**CITY OF GRASS VALLEY
ENGINEERING DIVISION**

ADDENDUM NO. 1

**CDBG MEMORIAL PARK FACILITIES IMPROVEMENT
PROJECT, PROJECT NO. 20-05**

ADDENDUM NO. 1

CITY OF GRASS VALLEY ENGINEERING DIVISION
**CDBG MEMORIAL PARK FACILITIES
IMPROVEMENT PROJECT
POOL CONSTRUCTION PLAN**

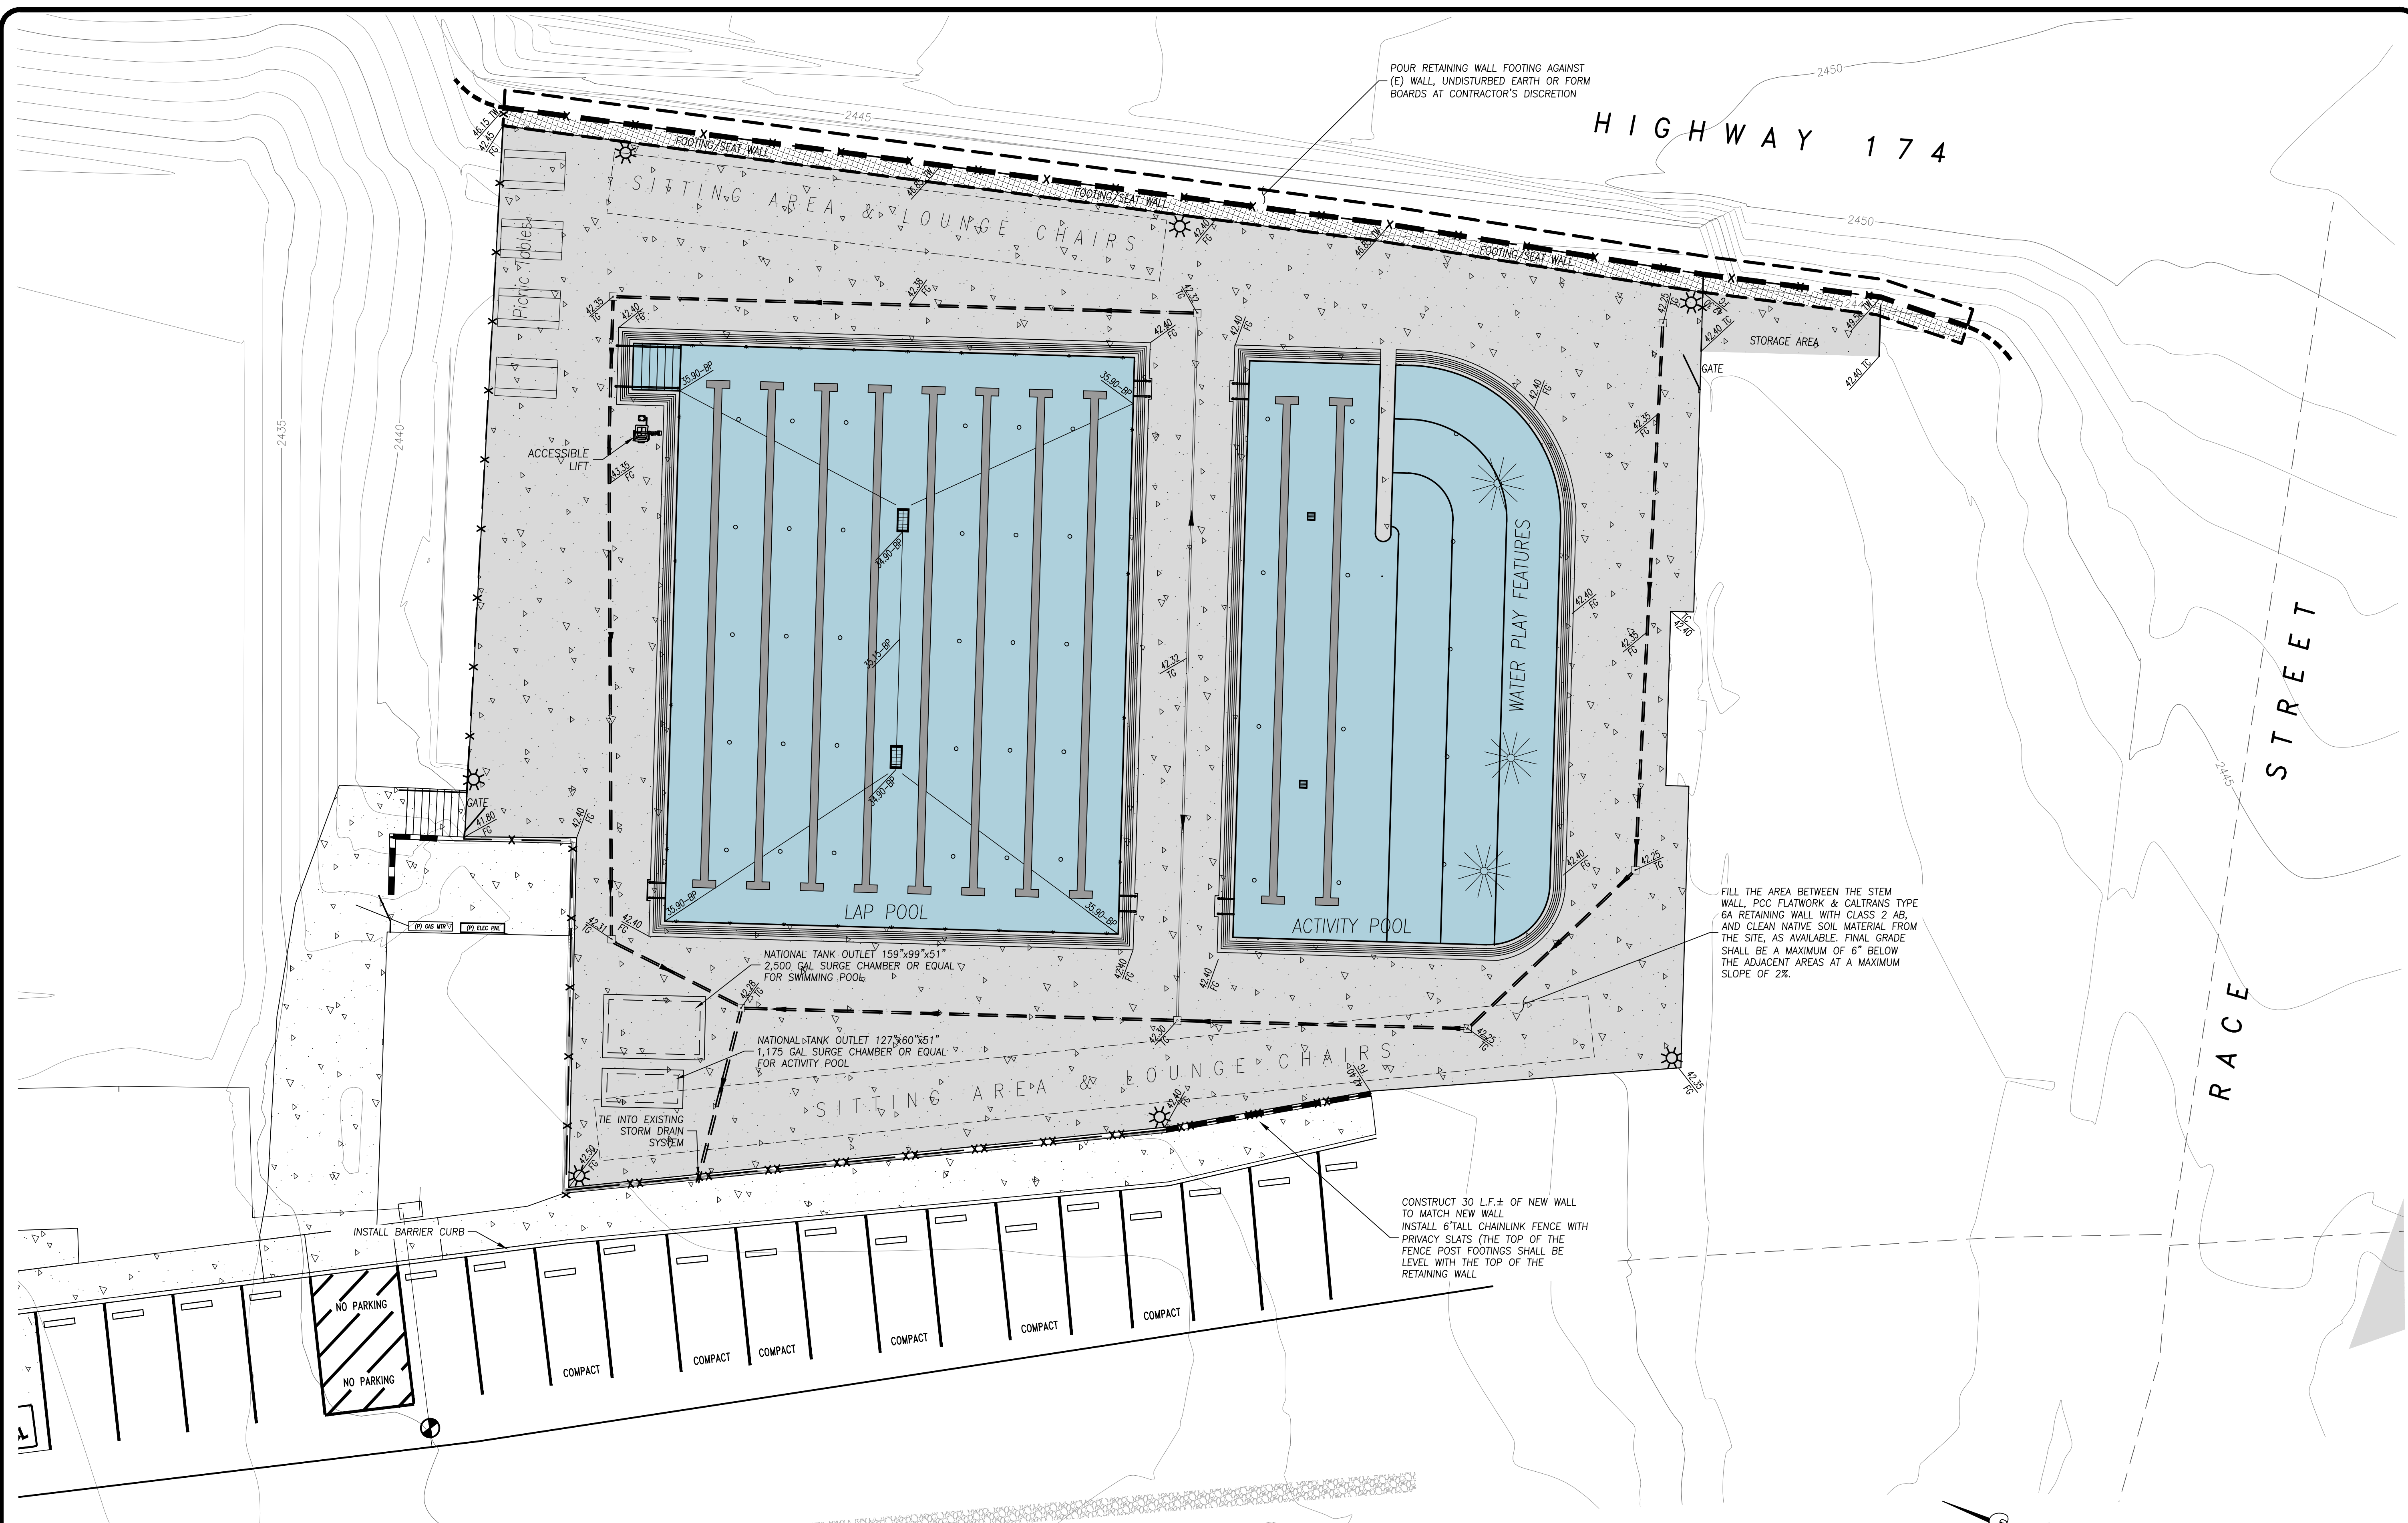
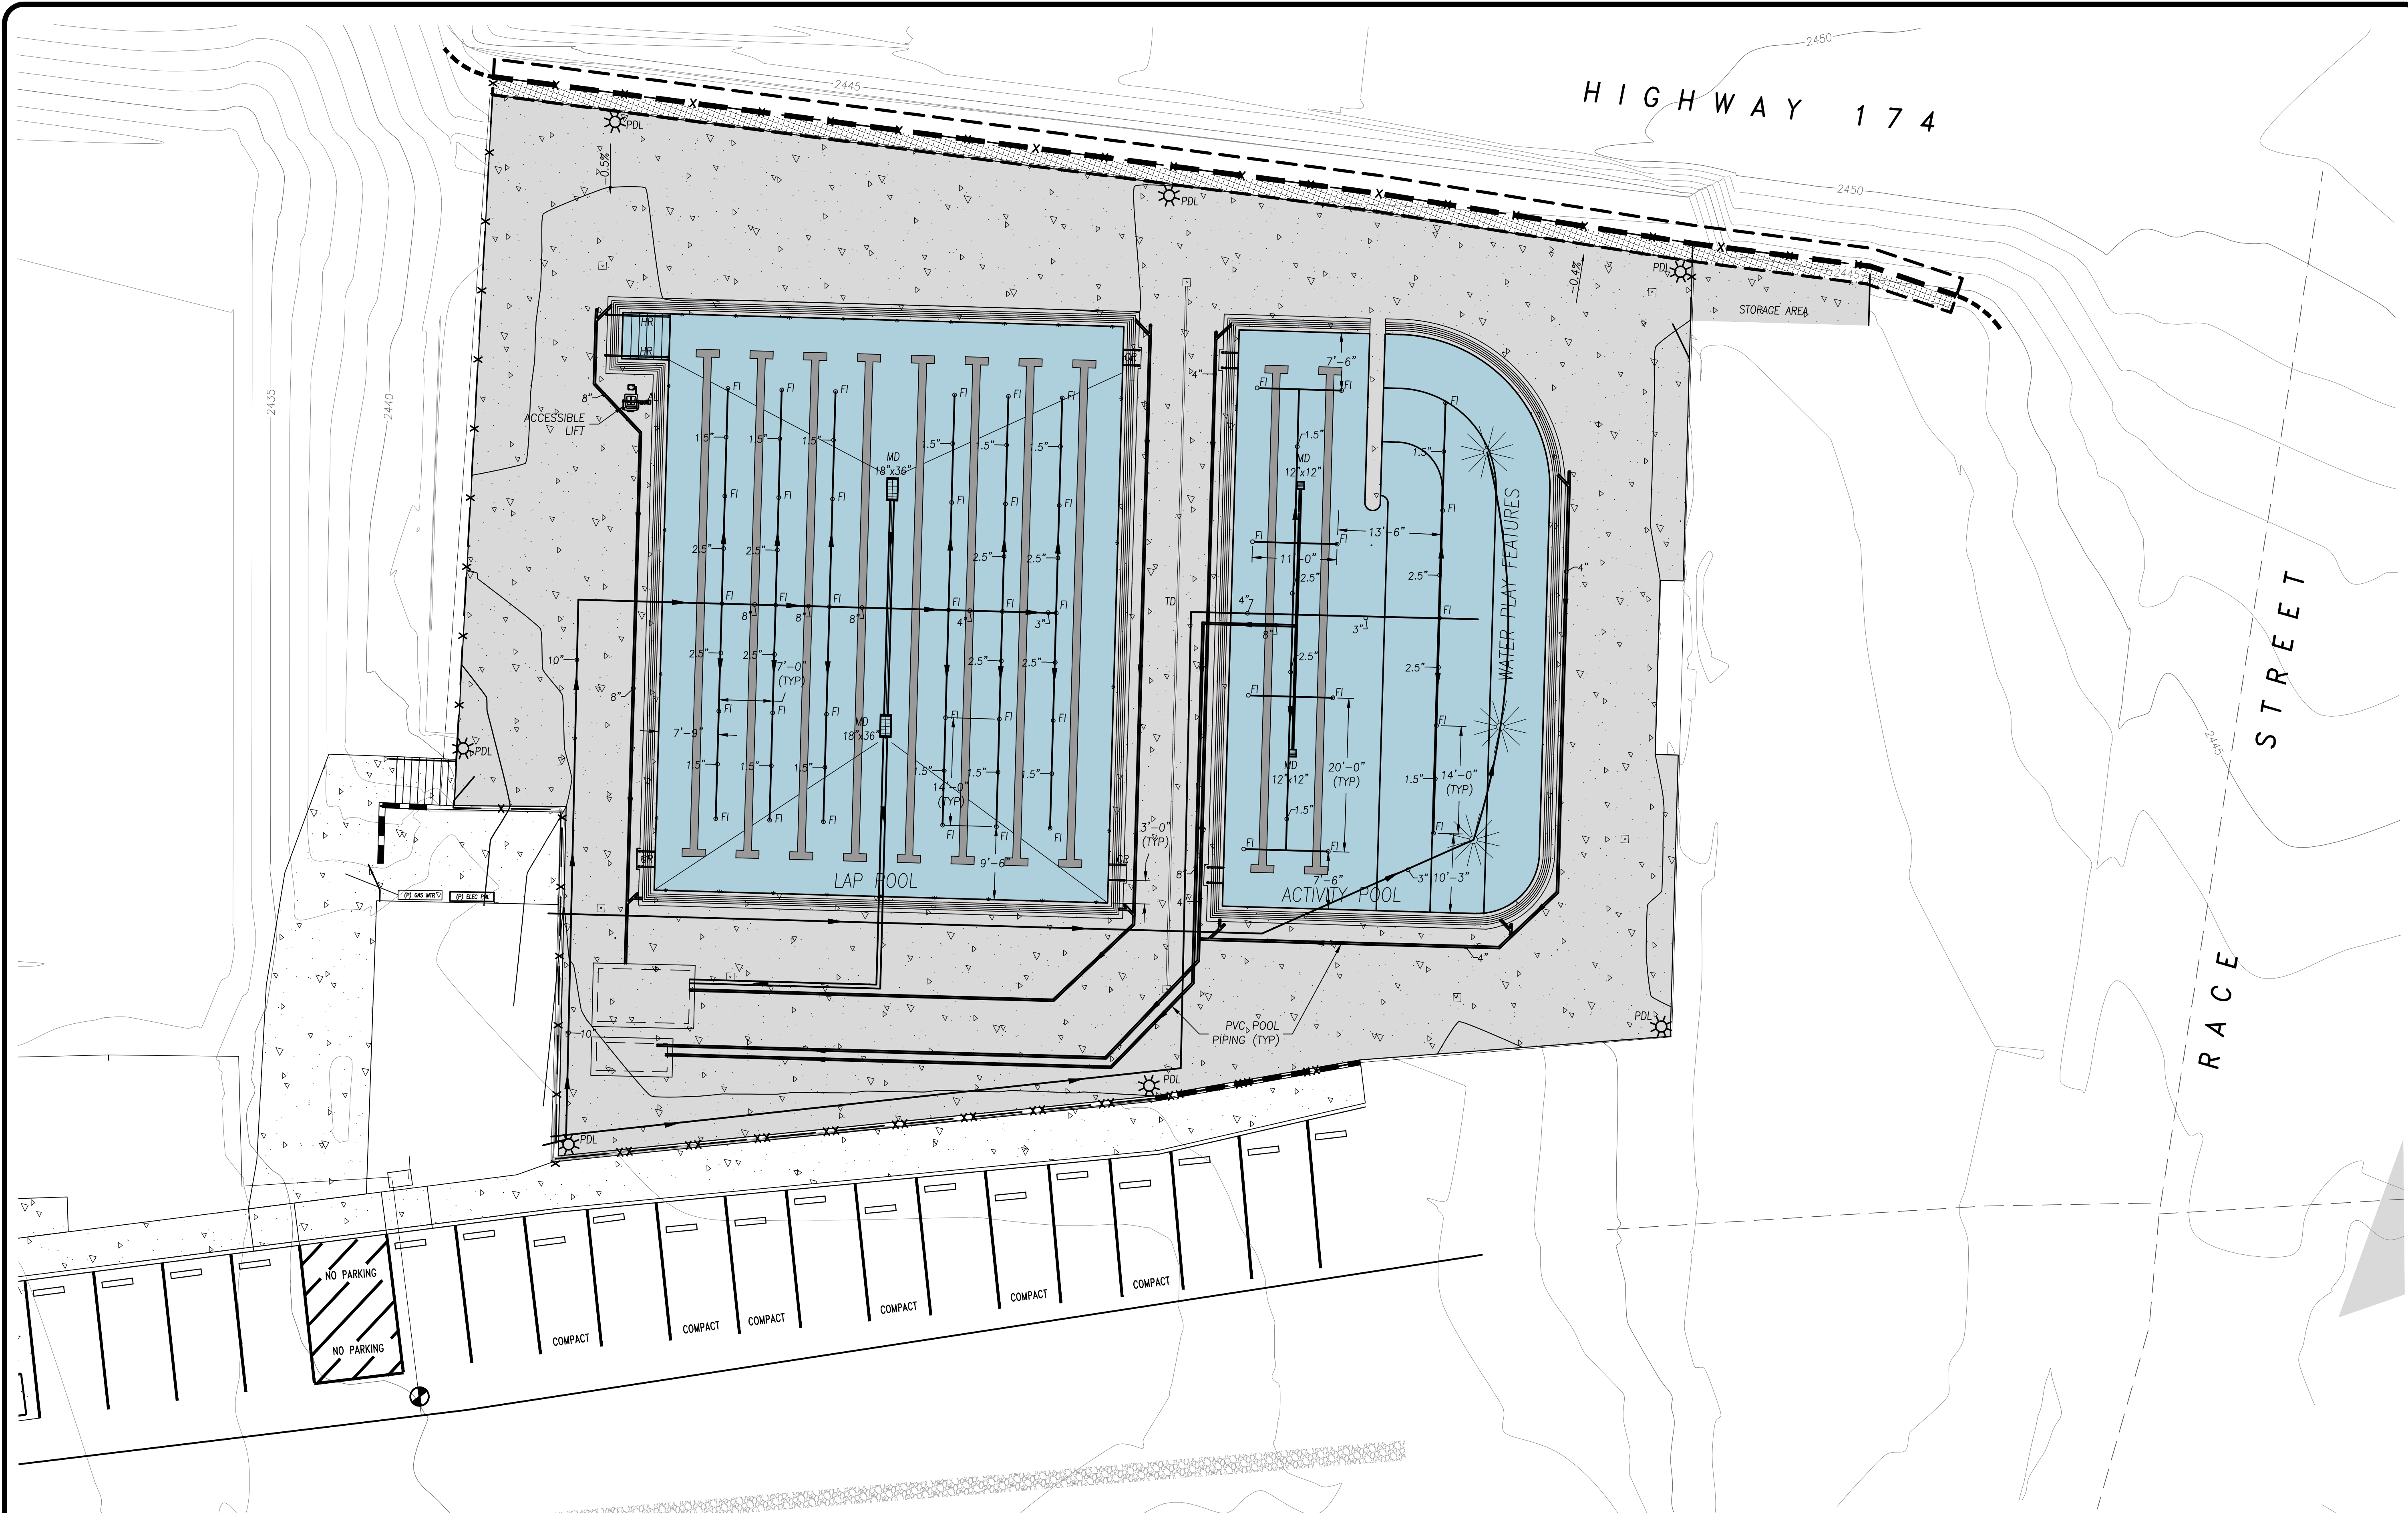
1. Sheet 1, Sheets 3 through Sheet 6, and Sheet 19. Replace the sheets in their entirety with the attached revised sheets. Remove reference to pool details. Modify the Activity Pool layout and cross sections. Move Seat Retaining Wall detail to sheet 19.
2. Sheets 7 through Sheet 9. Delete all pool details from the bid plan set.

REVISIONS		APPROVAL	Date
No.	Description	Engr Init	By
1	REVISE ACT POOL LAYOUT		BPJ

CITY OF GRASS VALLEY ENGINEERING DIVISION
**CDBG MEMORIAL PARK FACILITIES
IMPROVEMENT PROJECT**
POOL UTILITY PLAN

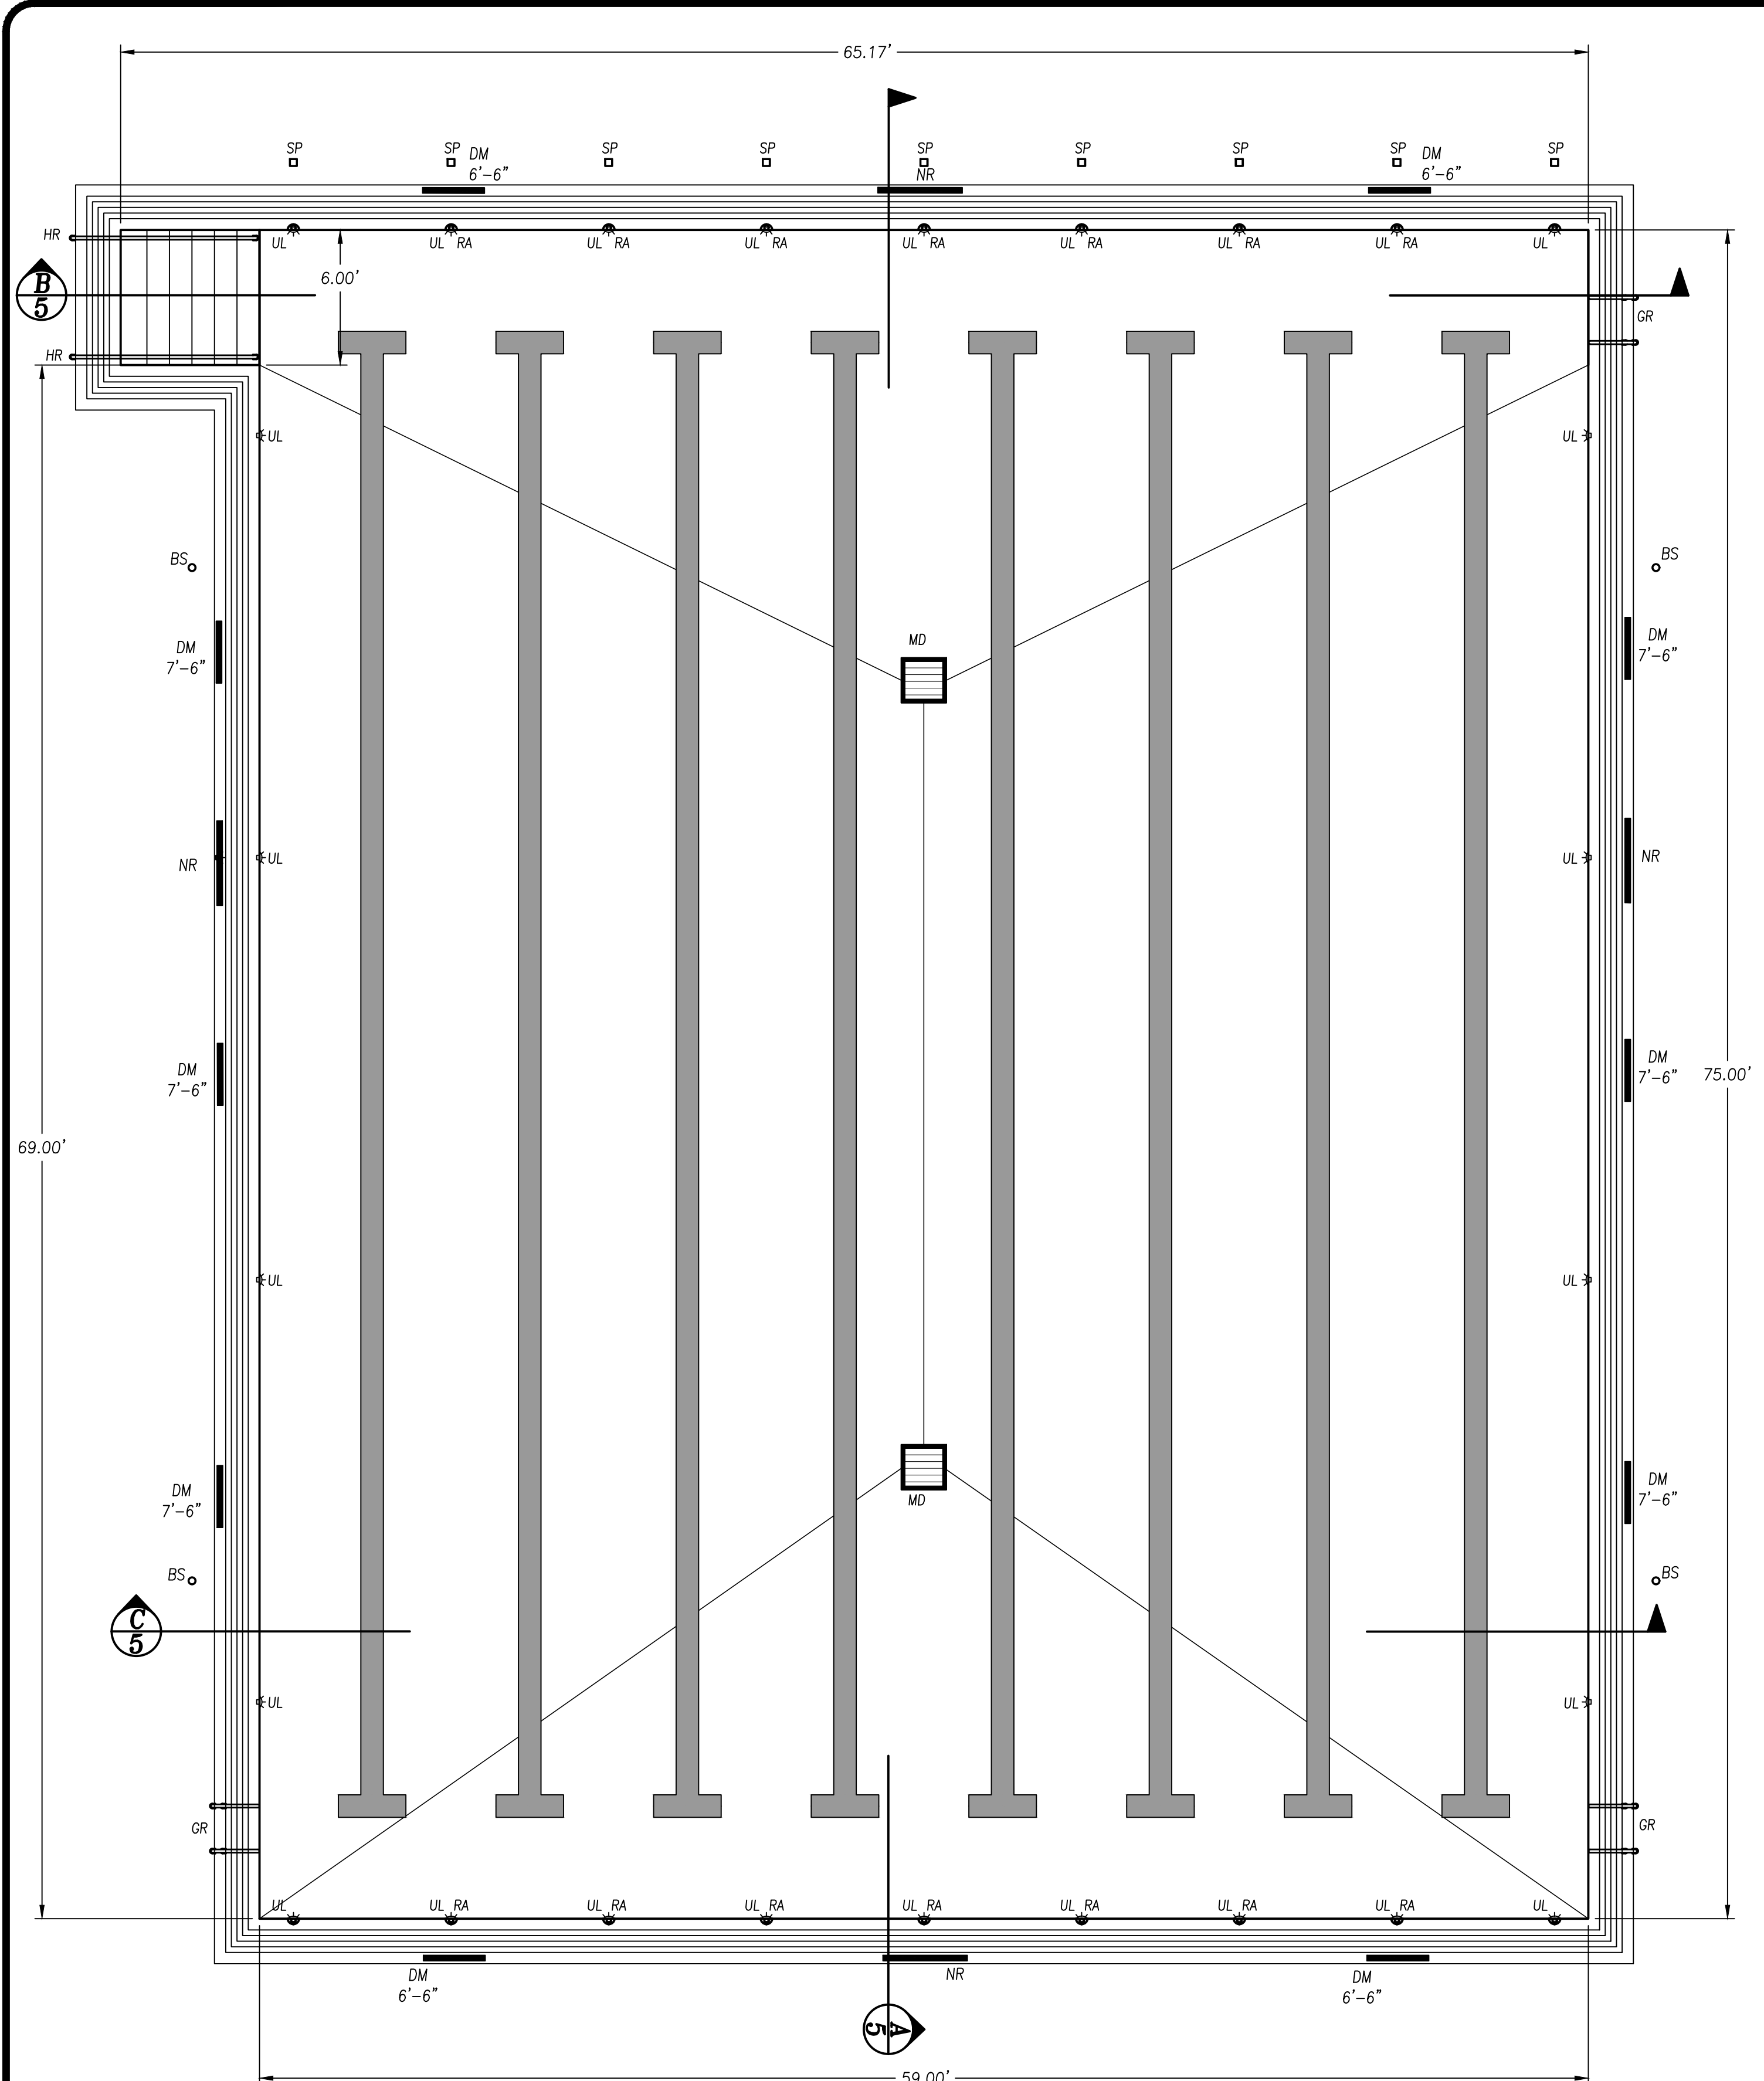
No.	Description	Engr Init	Date
1	REVISE ACT POOL LAYOUT	BPJ	3/29/21
